September 6, 2016

Subject: Comments from the RM11E Group on the Portland Harbor Superfund Site Proposed Plan and Feasibility Study

The River Mile 11 East Group (RM11E Group)¹ is providing the following comments on the Proposed Plan (PP) and Feasibility Study (FS) that were issued by the U.S. Environmental Protection Agency (EPA) for the Portland Harbor Superfund Site (PHSS) on June 8, 2016. The comments build upon those the RM11E Group provided to EPA for transmittal to the National Remedy Review Board (NRRB) and the Contaminated Sediments Technical Advisory Group (CSTAG) (collectively, the Boards) in October 2015. The RM11E Group's comments are based primarily on the Supplemental Remedial Investigation and Feasibility Study (Supplemental RI/FS) work that has been and continues to be conducted by the RM11E Group under the 2013 Administrative Settlement Agreement and Order on Consent (AOC) for Supplemental RI/FS Work with EPA (RM11E AOC).² Thank you in advance for considering these comments as you develop the Record of Decision (ROD).

FIGURE 1
Total PCB Aroclor Concentrations
Reoccupied Surface Sediment
Sample Pairs

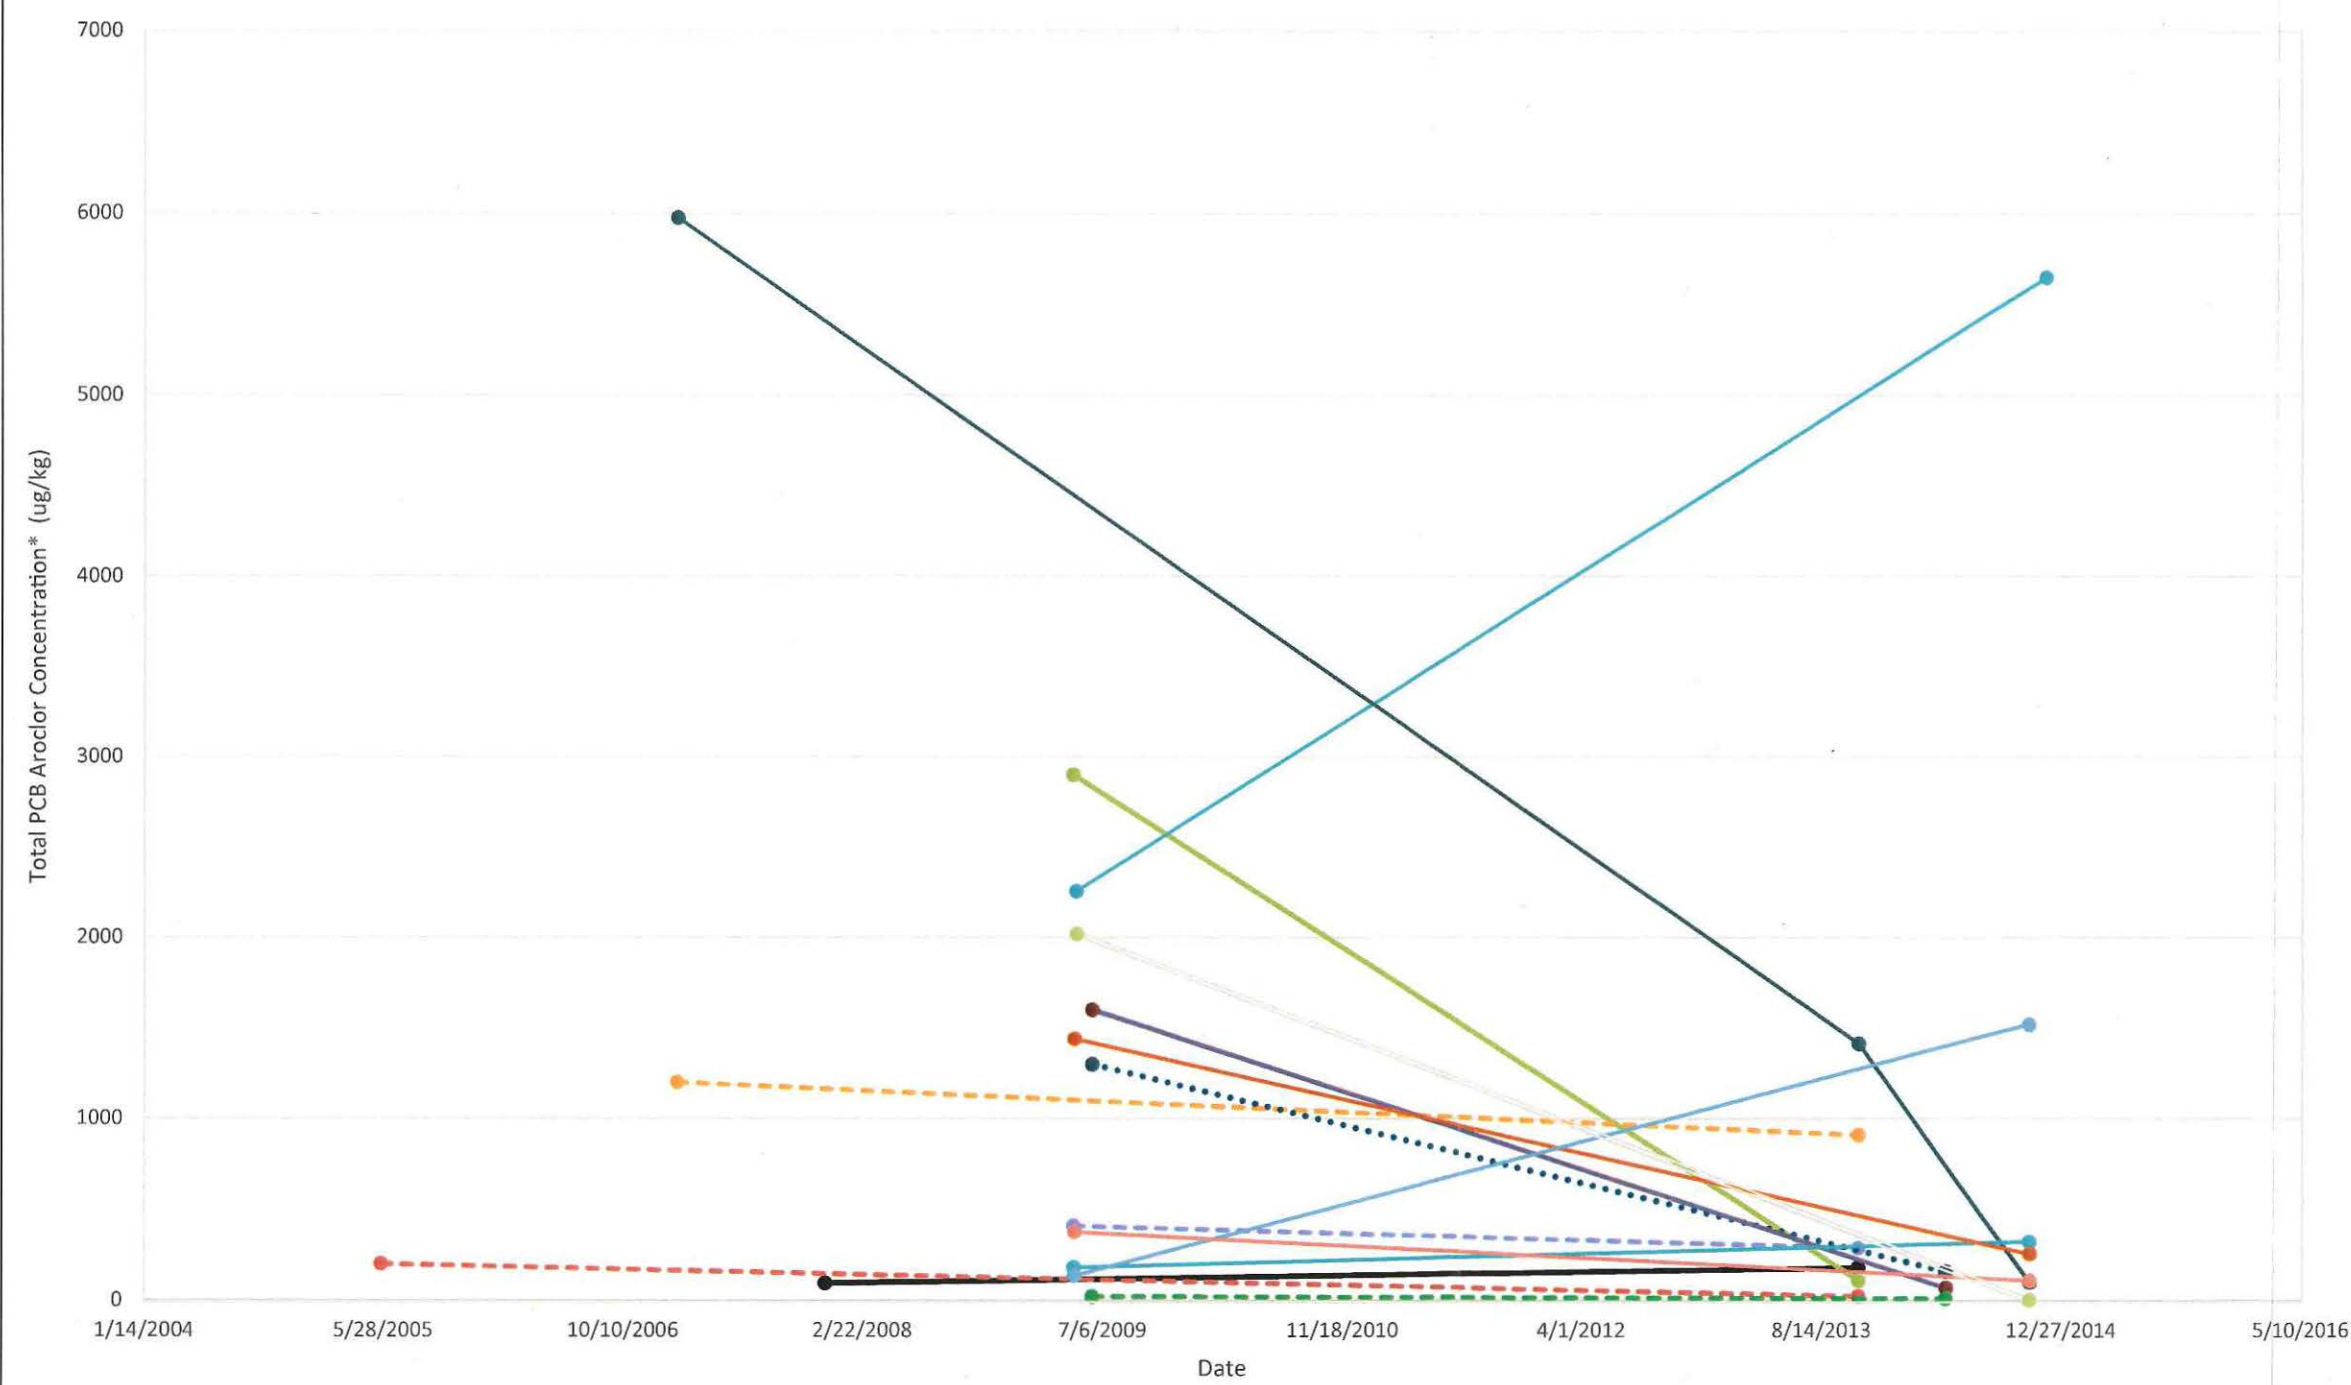
As stated in the December 5, 2014 letter to the EPA and the October 2015 letter to the Boards, the RM11E Group requests that EPA include these EPA-required and EPA-approved data in the Sitewide RI/FS database. EPA's failure to include the new data in the FS and PP has resulted in

⁶ Note that the sample (SS-097-11252014) in Figure 1 that has the most significant increase in PCB concentrations was not collected as part of the RM11E RI/FS work. The sample was collected by a third party in 2014 (Kleinfelder, 2015) and the RM11E Group has concerns about the comparability of that data to existing sediment data. In particular, the new sample was collected approximately 28 feet from the previous sample RM11E-G029, which was collected in 2009. In addition, the 2014 sample was collected from the upper approximately 10 cm of sediment whereas 2009 sample was collected from the upper 19 cm, and the grain-size results indicate that the 2009 sample had a higher percentage of gravel (20 percent) than the 2014 sample (4 percent). For these reasons, caution should be used when comparing the results of these distinct sampling events.

Figure
9.1

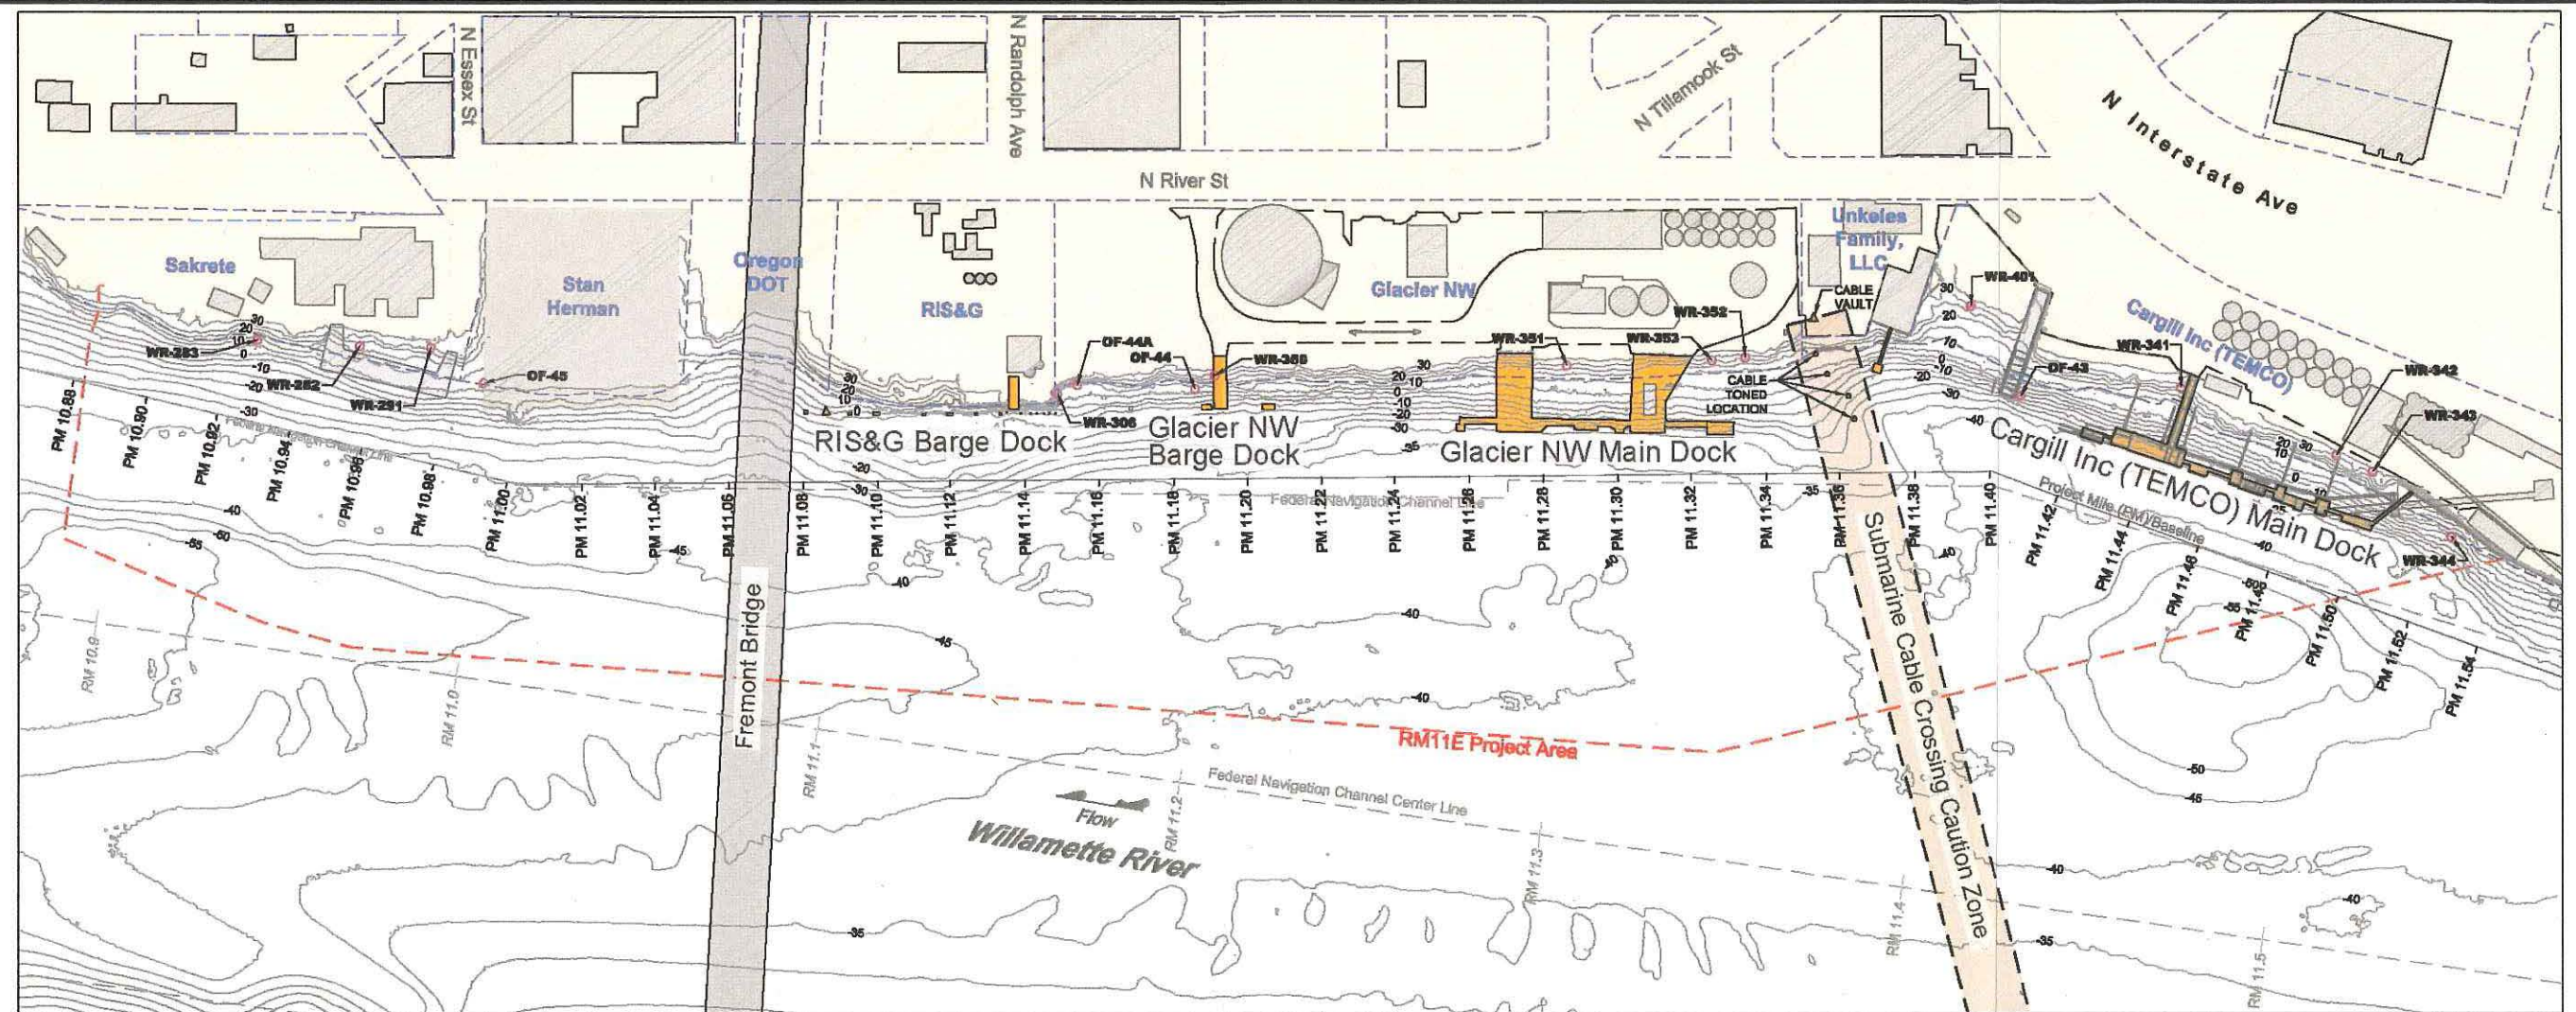
1. Facility Operations (Figure 9.1)
2. Navigation Clearance (Figure 9.2)
3. Construction Access (Figure 9.2)
4. Submarine Cable Crossing (Figure 9.2)
5. Groups of Vertical Pile Remnants (Figure 9.3)
6. Large Undifferentiated Debris (Figure 9.3)
7. Oversteepened Slopes (Figure 9.4)
8. Structure Stability and Capacity (Figure 9.1)
9. Vessel Propeller Wash (Figure 9.5)
10. Wave Action (Figure 9.5)

- Underwater Cables, Docks, Steep Slopes Affect Technology Assignments. There is a significant risk that the underwater utility cables and operating docks within RM11E could be damaged or destroyed by the technologies assigned in the PP. For example, the PP calls for dredging where active remediation is required in the navigation channel and in designated future maintenance dredge (FMD) areas (PP Figure 10a and 19f). At RM11E, however, this would mean dredging in the same location as buried underwater cables that supply electricity to downtown Portland (see ISR Figure 9.2). While dredging is likely not implementable over the buried cables as they near the banks, there may also be limitations on the ability to cap over the underwater cables due to the resulting impingement on navigational depth (ISR Section 10.2.4.). Similarly, several active commercial docks within the RM11E area are on steep slopes that already have a high degree of potential instability (see ISR Figure 9.4). Portions of these operating dock structures may also be inaccessible for purposes of implementing a variety of active RA measures (see ISR Figure 9.2). The PP’s conceptual presumptive remedies of dredging and/or capping under or around such docks would need to

Figure 9.4

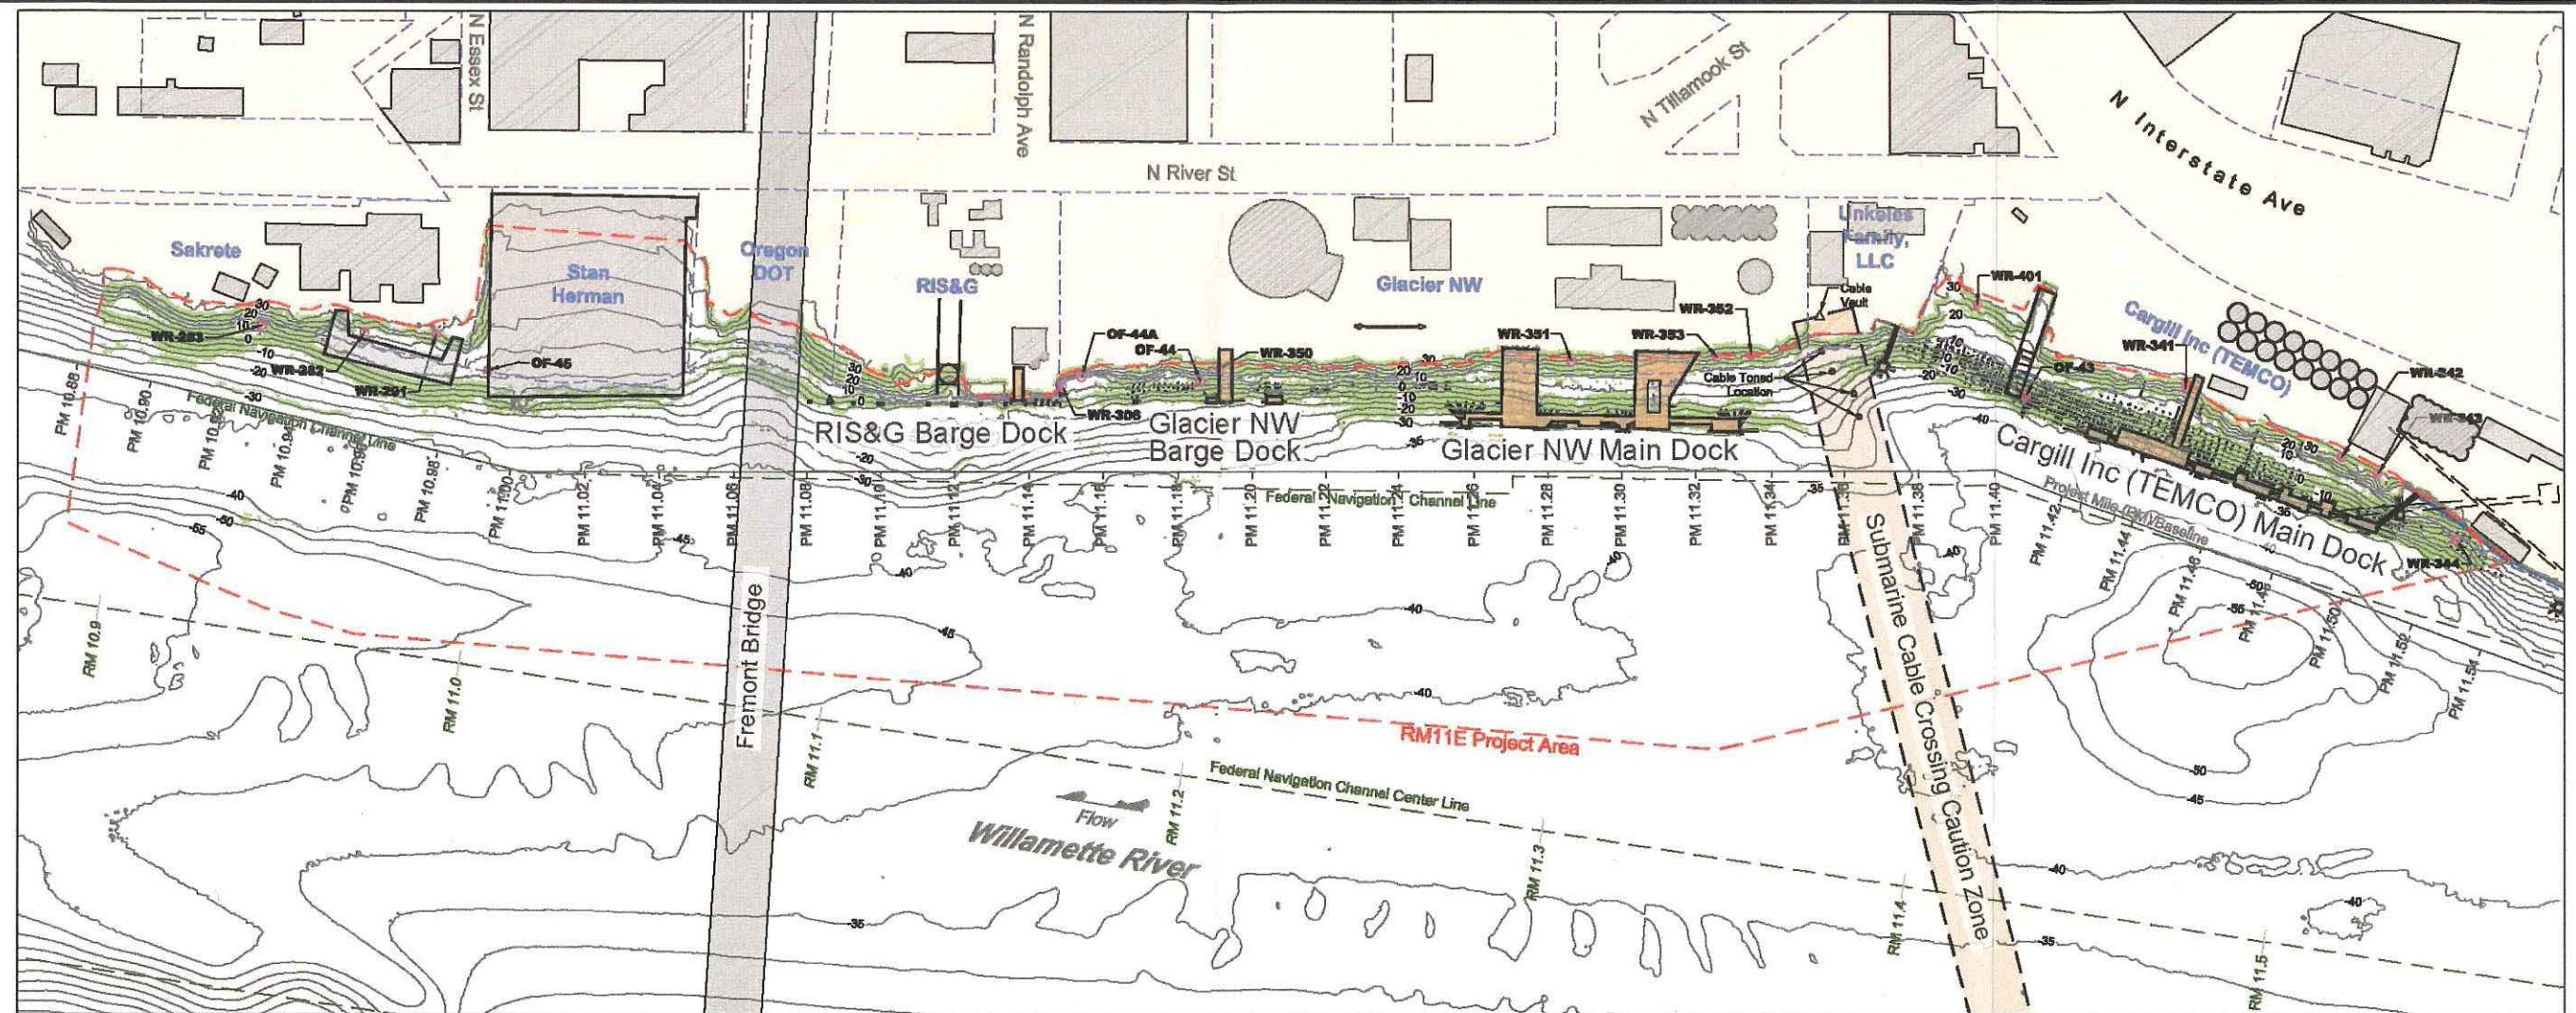
- Shoreline and Bank Stability Limit Remedial Options. The geotechnical characteristics and submarine conditions of RM11E will limit application of some of the current PP technology assignments in the RM11E area. Assigning technologies to the RM11E area according to the decision tree outlined in the PP could result in significant shoreline and bank collapse and create upland structure instability. The following two examples pertain to the conceptual discussions in the PP concerning optimal shoreline slopes and removal of remnant structures.

- The FS (Section 3.4.5, pg. 3-12) states that the optimal slope for habitat considerations is less than 5H:1V. Most of the existing slopes in the RM11E area are significantly steeper than these slopes, and the space between shoreline structures and navigational areas is very narrow. Accordingly, attainment of the optimal 5H:1V slope laybacks are not only impractical, but physically impossible in several areas and could undermine active, near-shore industrial and commercial infrastructure. During RD, evaluation must include how or whether slopes in the RM11E area could be laid back, and in those areas where it may be possible, assess whether it can be accomplished without impairing upland structures, navigational access, or both (ISR Section 10.2.7.)
